PLANNING AND ZONING COMMISSION AGENDA

**STAFF REPORT
KETCHUM PLANNING AND ZONING COMMISSION
REGULAR MEETING OF JUNE 27, 2016**

PROJECT: Bracken Station Conditional Use Permit (CUP)

FILE NUMBERS: #16-034

Attachment F.

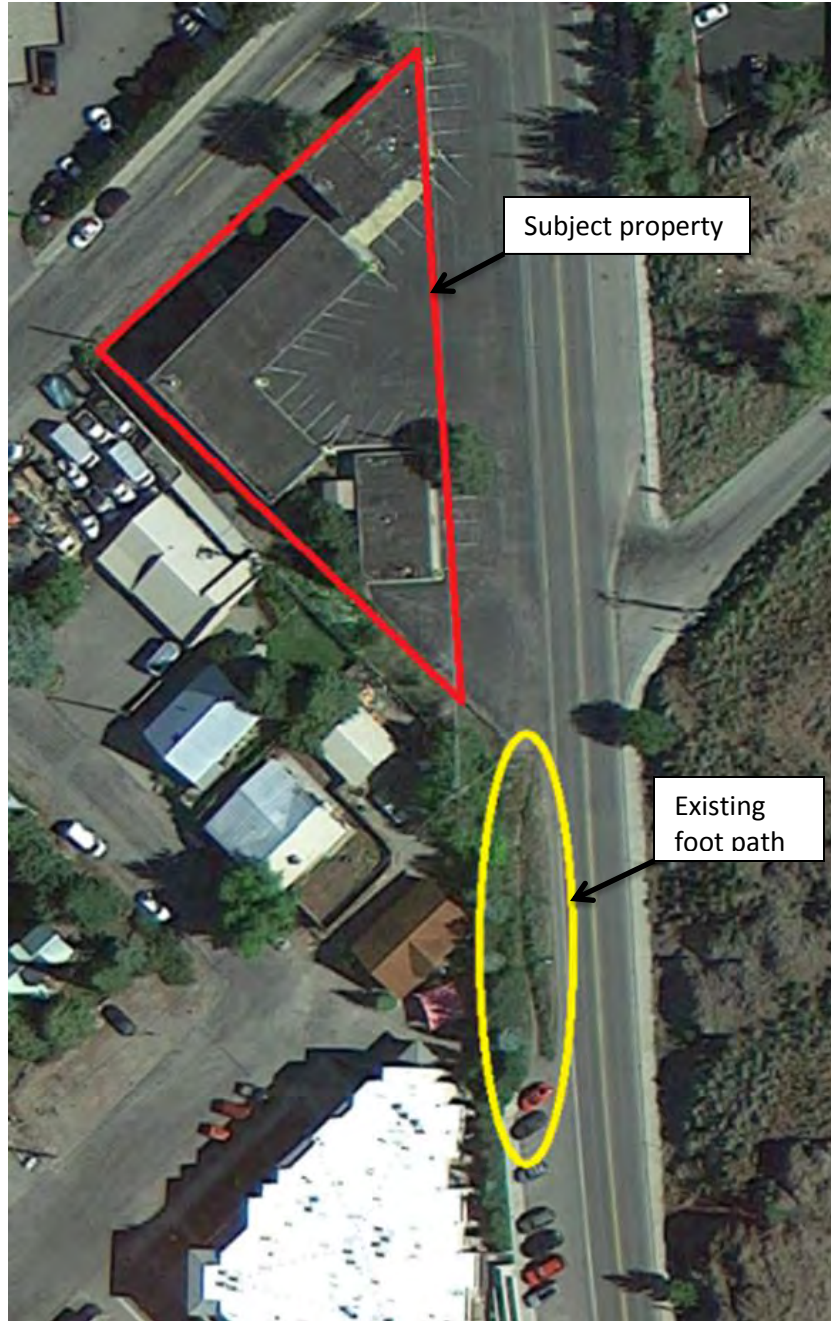
| Recommended Public Improvements to Mitigate Impacts of Development | |
|--|--|
| Main Street Sidewalk Extension | <p>Staff recommends extending the 6' sidewalk on Main Street an additional 175' in length (approximately) to connect to the existing public sidewalk located adjacent to the Frenchmen's Place condominium development.</p> <p>There is not currently a sidewalk connecting the two properties but there is an informally created and well-worn pedestrian foot path; the new uses proposed for the site will generate additional pedestrian trips and a 6', paved, and ADA compliant sidewalk is recommended for safety purposes. See Attachment F.</p> |
